From: Matt Dumont
To: Cheryl Low
CC:
Date: 14/09/2026
Subject: RFI responses for groundwater modelling

This response memo has been prepared to address the concerns raised in the submissions received on the modelling work undertaken for the Bendigo Ophir Gold Project. Documents considered in this response memo are:

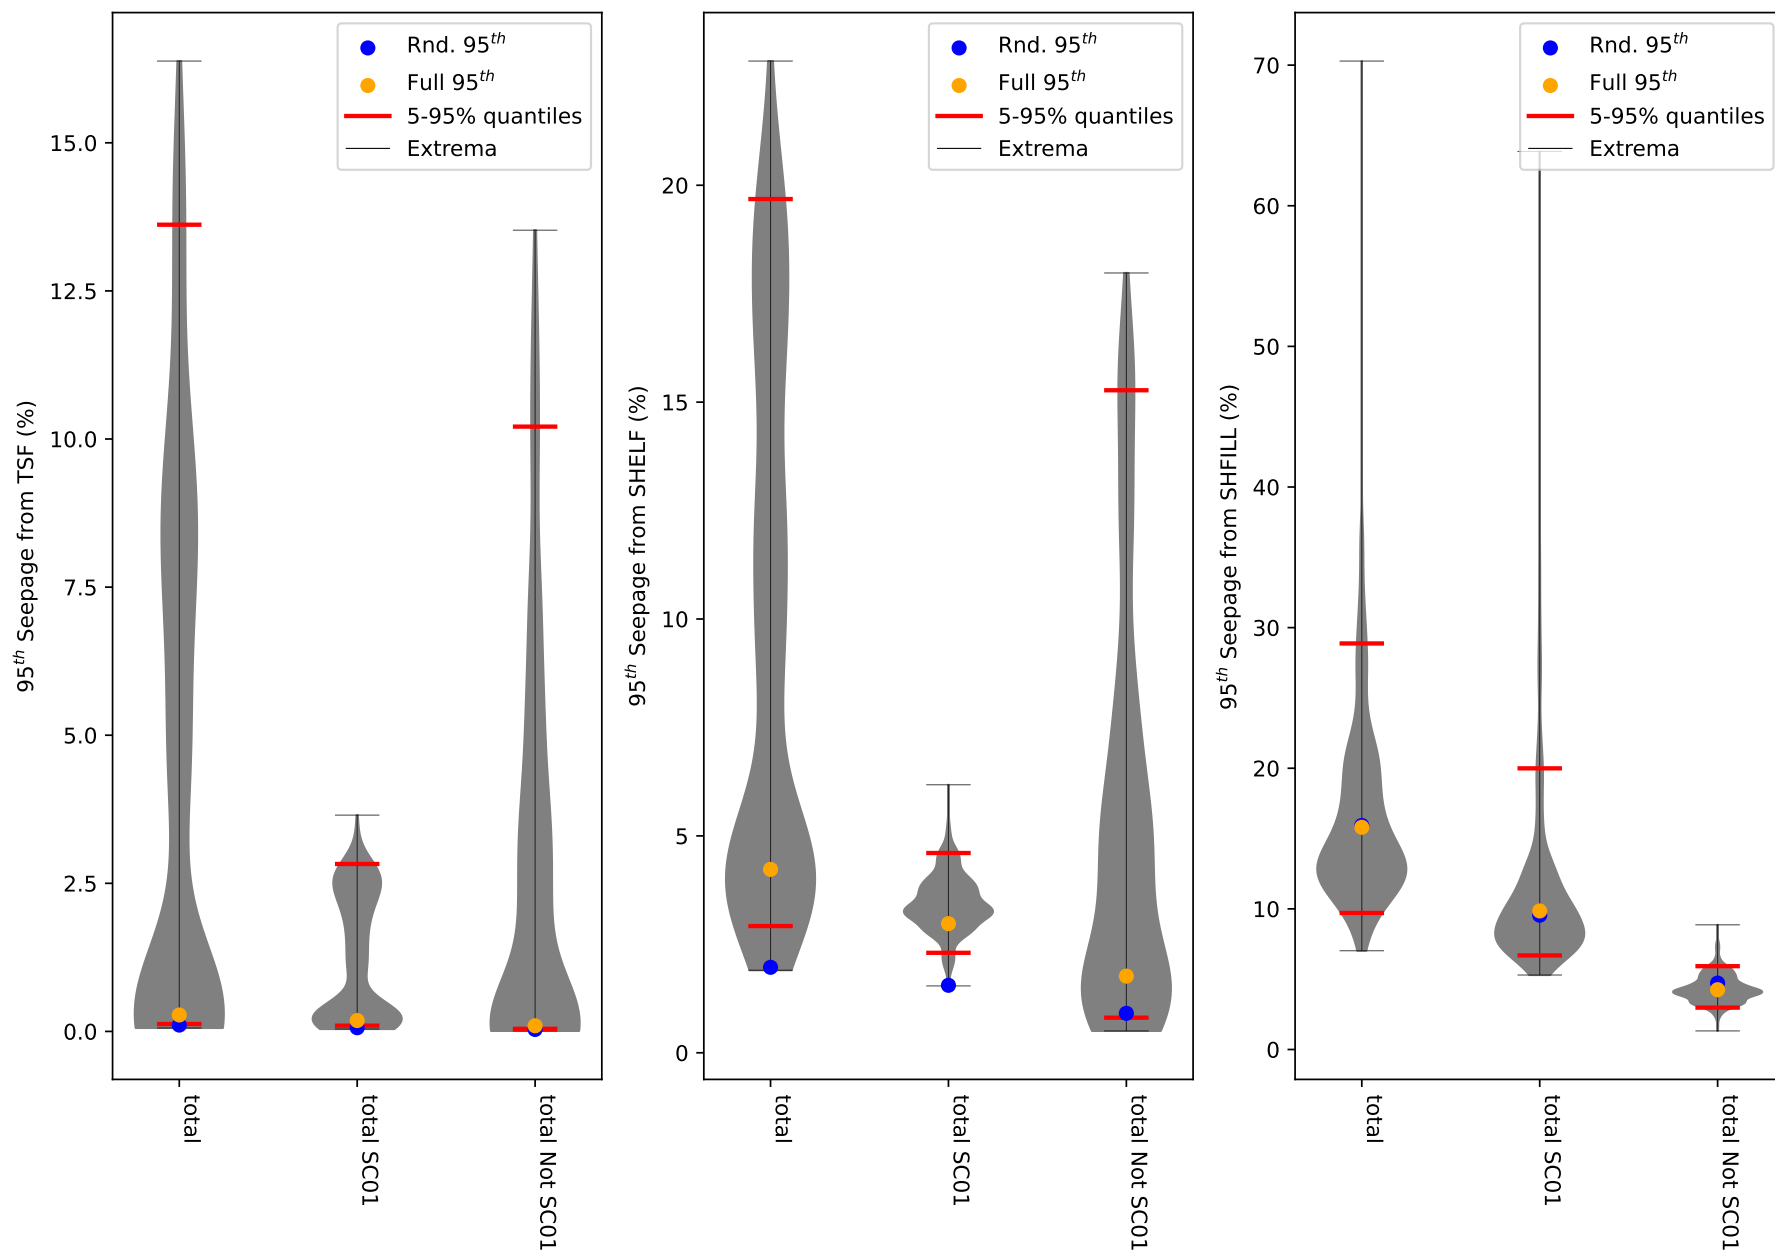
Concerns were raised regarding the stochastic forward suite creation and selection. Morgan (2026) suggested that the stochastic suite was not created in a manner that was consistent with the assumption that the probability of a model realisation in the stochastic suite is the same as the probability of the model parameters. We agree that this is the case, but disagree with the ultimate conclusion that the stochastic suite may under-predict the potential for lost seepage. The goal was to explore the unlikely but possible parameter space that affects the seepage rate as opposed to the random parameter space. In a raw stochastic suite many model realisations will be “wasted” on parameter combinations that do not affect the prediction of interest. To assess the potential bias of the non-random suite, we ran the same filtering step on all models and only the initial 1620 models (yielding 208 unique realisations) that were selected randomly from parameter space. We then compare the 95th percentile of those 208 models to bootstrapped random set of 208 models which match the filtering criteria and were selected from the guided suite. The results are shown in Figure 9.1. The results suggest that the guided suite provides a biased posterior, with the bias to predict higher rates of lost seepage. This provides confidence that the seepage estimates provided here are very conservative and that the true lost seepage rates are likely to be lower than those presented in our report.

Further Morgan (2026) suggests that the large reduction of seepage from the raw suite to the final suite is indicative of a true risk. We disagree and have provided detailed rationale for the filtering undertaken. For instance the high values of lost seepage from the TSF occurred when excess recharge lead to groundwater heads far in excess of the top of the Tailings Storage Facility - Dam. This is not plausible. Those high levels of recharge would be refused and instead form surface runoff to the TSF wetland. The commonly used generalised likelihood uncertainty estimation (GLUE) approach involves randomly drawing parameter sets then filtering those parameter sets for acceptable behaviour to produce a posterior distribution. Here we use the GLUE approach, but with a deliberate bias towards over-prediction of lost seepage.

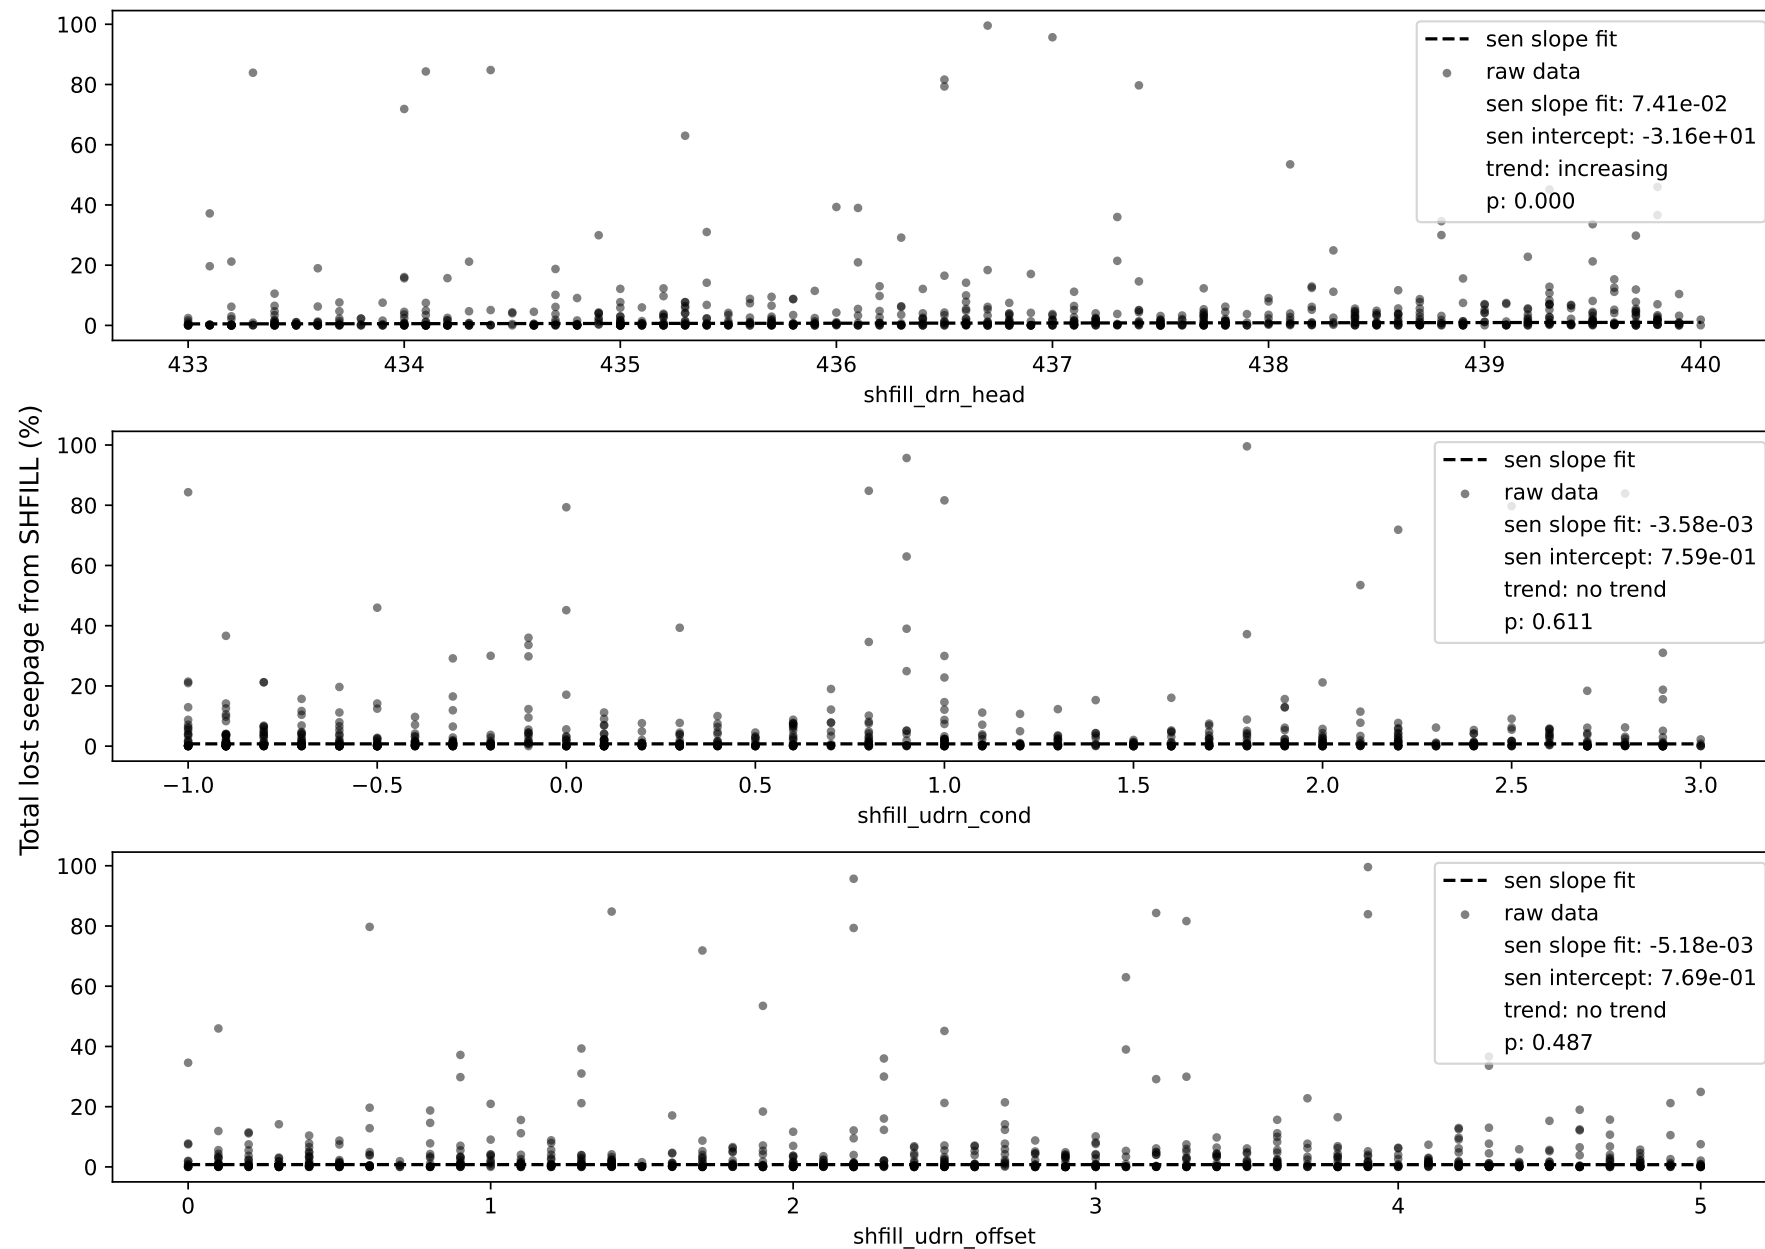
Multiple concerns were raised regarding the potential for additional seepage under less than optimal under drainage performance. First, we must note that the aforementioned failure of the underdrainage system, to our knowledge, only refers to the explicit underdrainage in the TSF. It is not clear that the other drainage systems (E.g., SHFILL, SHELF) are subject to the same failure mechanism. Our analysis suggested that sufficiently draining the SHFILL is an essential mechanism to reduce the likelihood of lost seepage. We explicitly included DRN cells to represent this drainage system, but we have not assessed the design requirements. It may be possible to meet these requirements with a higher hydraulic conductivity material base rather than explicit underdrainage, which would likely be much more robust. The purpose of the SHFILL “under” drainage is to ensure that discharge from the deep system that is predicted in this area would not cause a build up of water and potential discharge along the edges of the SHFILL or into the redirected Shepherds Creek. In our assessment of the TSF underdrainage, we did not find a significant impact of the potential drainage extensions (or the inclusion of underdrainage at all) on the predicted lost seepage from this component. The main predictor of lost seepage from the TSF were heads in the TSF in excess of the land surface, which then caused seepage to bypass the collection system. These high heads were driven by high recharge parametrisation paired with low hydraulic conductivity of the TSF material. This suggests that excess recharge would be refused and such high heads are unlikely to occur in practice.

Some responses suggested that we did not conduct any assessment of the failure of the underdrainage system. This is incorrect. While we did not explicitly model scenarios where the underdrainage systems had reduced performance, we did include a number of parameters to represent less efficient underdrainage systems. These include the variable conductance of the underdrains and the variable inverts of the underdrains and other drainage systems (e.g., SHELF drains). [Morgan \(2026\)](#) correctly identified these simulations, but requested further presentation of the results. The effects of underdrainage extent (and thus performance) on the TSF is already present in figure 8.3 of the modelling report, which we will not re-produce here. [Figure 10.1](#) shows the Mann Kendall trends of the relationship between the lost seepage from the SHFILL and the invert level of the SHFILL drain at the Shepherds Creek Valley Fill - Seepage Dam (`shfill_drn_head`), and the hydraulic conductivity and invert levels of the SHFILL underdrains (`shfill_udrn_cond` and `shfill_udrn_offset`). There is no trend between the lost seepage and the underdrain hydraulic conductivity or invert offset, suggesting that even at reduced performance the underdrainage system is still effective at reducing the likelihood of lost seepage. There is an increasing trend against the invert level of the SHFILL drain, but this relationship is very small (Sen Slope of 0.07% increase in lost seepage per 1 m increase in invert level). The SHFILL drain invert is a very aggressive structural sensitivity parameter. These results further confirm that an assessment of the reduced performance of the underdrainage system is not likely to significantly affect the predicted lost seepage from the SHFILL.

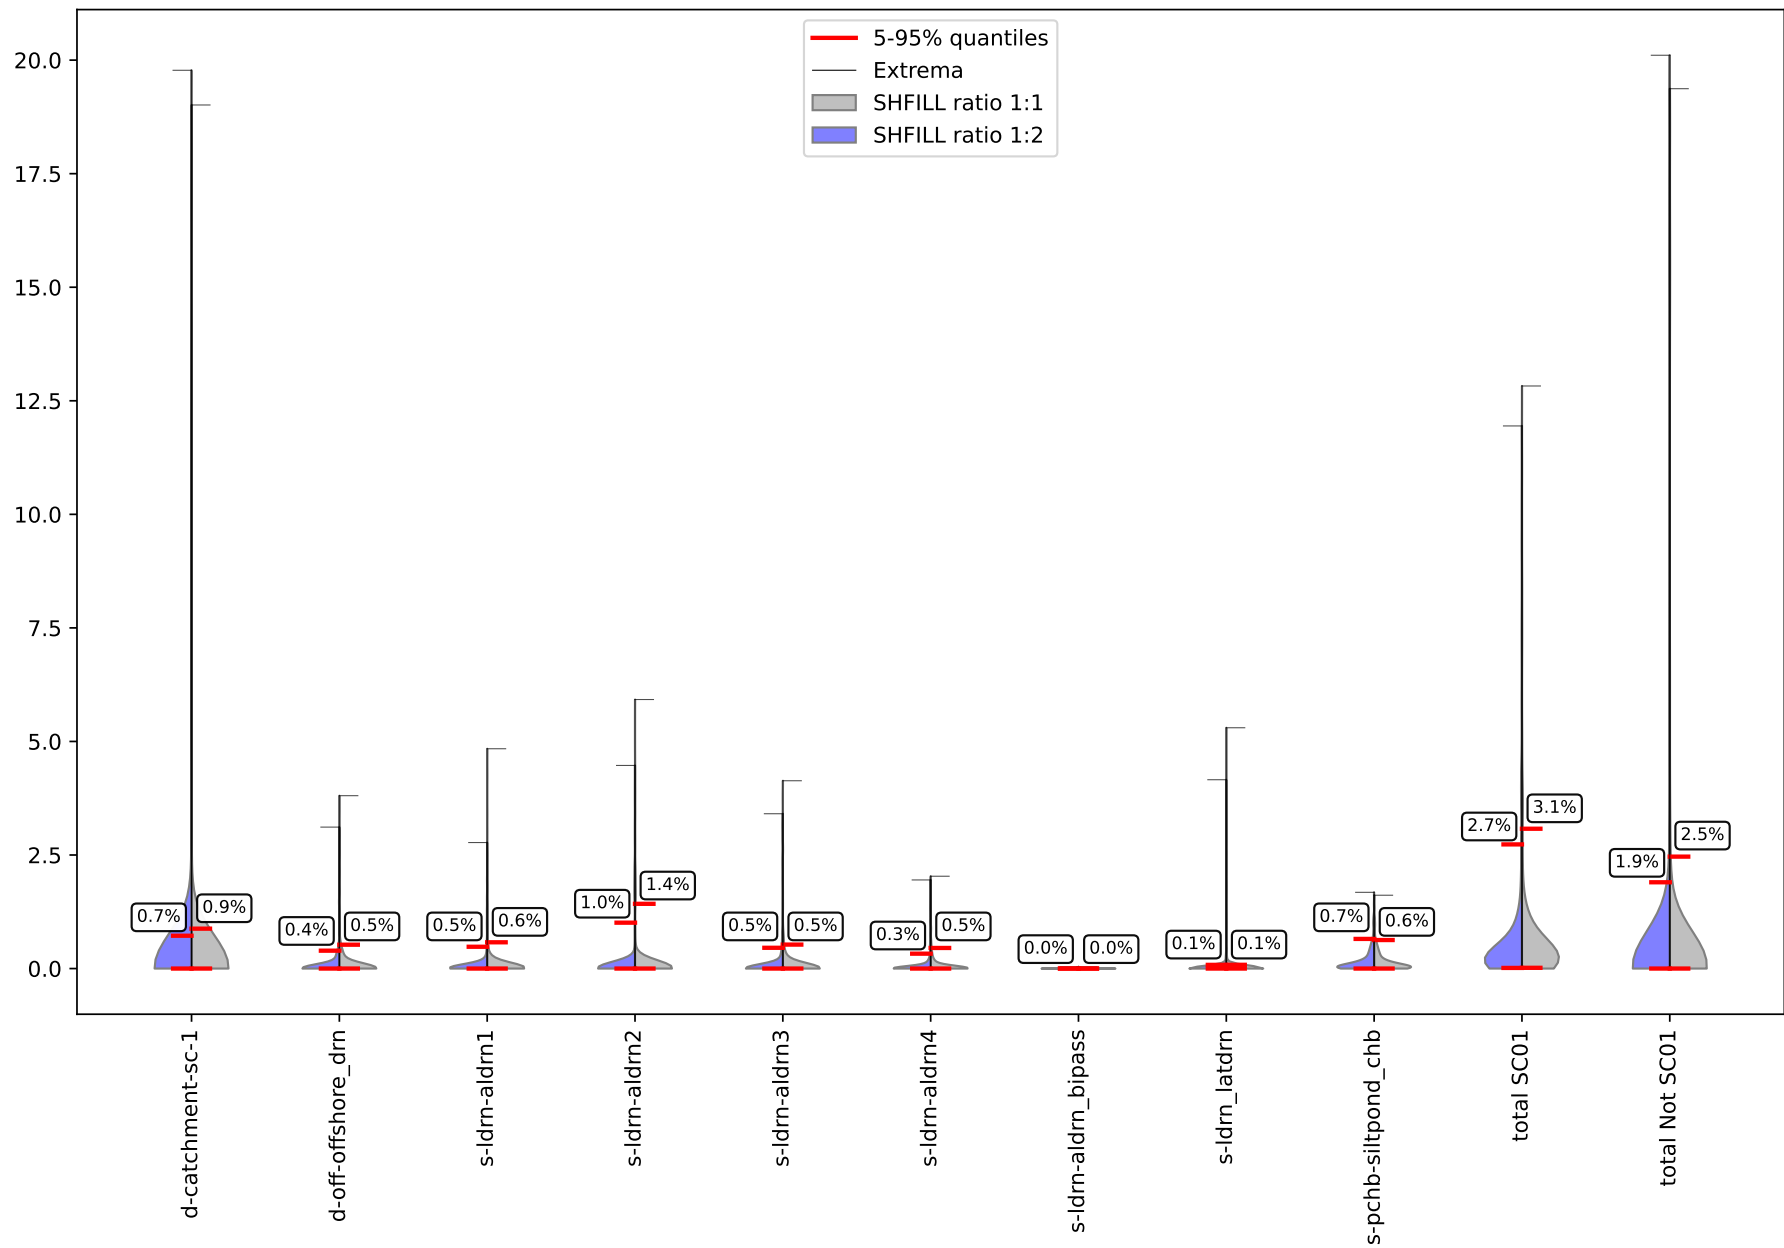
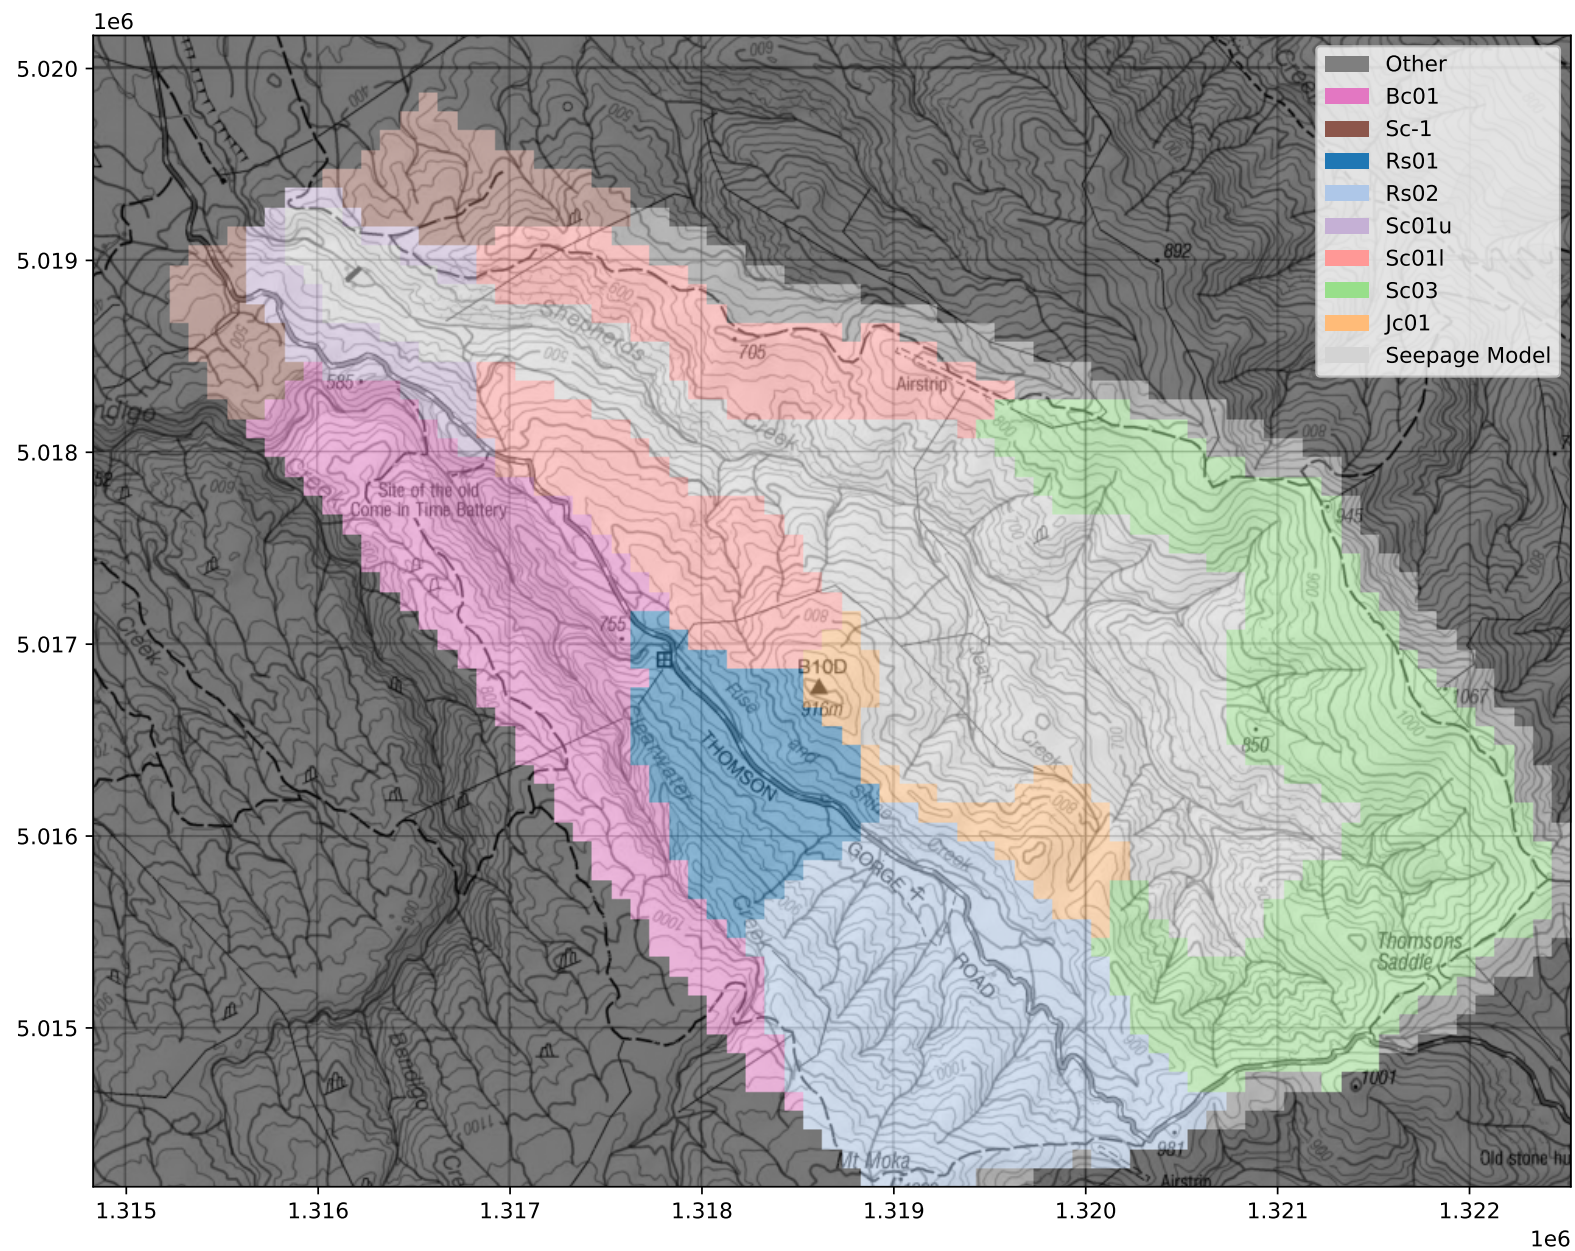
Multiple concerns were raised regarding the potential for lost seepage to bypass the monitoring point in Shepherds Creek (SCO1). There also appears to be a conflation between seepage missed by SCO1 and seepage that is not detected by the monitoring network. Our work specifically assumes that the monitoring network includes surface water observations (e.g., at SCO1) and groundwater observations in the alluvium, colluvium and weathered schist in the lower Shepherds Creek Gorge. We agree with the submitters that seepage that bypasses the primary collection system may bypass SCO1, which is why a groundwater monitoring network in the lower Shepherds Creek Gorge is essential. The constrained topography of the gorge provides a natural monitoring point, which will minimise the potential for seepage to bypass the monitoring network.

The model is designed to differentiate between seepage discharged to SCO1 and adjacent groundwater, and seepage that discharges via the deeper fresh schist pathways. The model is not capable of differentiating between seepage that discharges to SCO1 and seepage that flows through the alluvium, colluvium, and weathered schist under SCO1. Specifically, we characterise the lost seepage which will not be detected by the monitoring network as seepage that discharges to either the OFFSHORE zone or to the following deep model DRN zones (see [Figure 11.2](#)):
